Stewart Facility 5500 Snyder Avenue, Carson City, NV 89701

Request for Permission to Undertake Structural or Visual Alterations

STEWART COMPLEX - BUILDING #4 PARKING LOT

RE: concrete work south of Bldg. 4

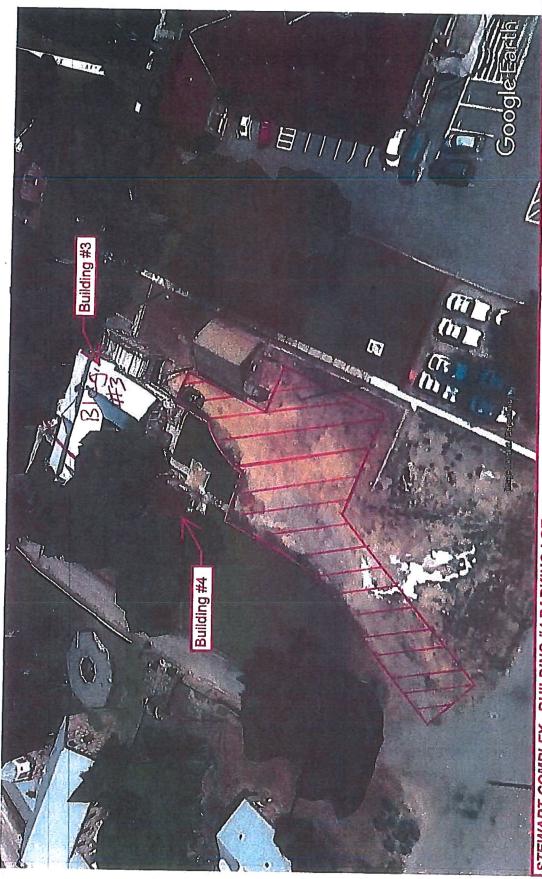
The qualified archaeological monitor needs to be present and able to observe, in real-time, the removal of soil. This allows the monitor to observe if archaeological resources are encountered and to halt work in order to avoid further damage to the newly discovered archaeological resource.

In order to determine the archaeological sensitivity of the project area, the SHPO consulted the Nevada Cultural Resources Inventory System (NVCRIS). According to these records, the project area has not been inventoried for archaeological resources and no sites have been recorded; however, numerous archaeological resources have been documented elsewhere on the Stewart Campus. The depth of existing ground disturbance below the initial grading of the project area is unknown and could contain subsurface archaeological deposits, and the project scope calls for several inches of additional excavation. Thus, the SHPO recommends a Secretary of the Interior—qualified archaeological monitor be present for the removal of the soil prior to paving.

You indicated that Sherry would invite a couple of qualified archaeologists to participate in the monitoring process. Once you've determined who the monitor will be, please notify our office so that we can approve their qualifications and give this project its notice-to-proceed.
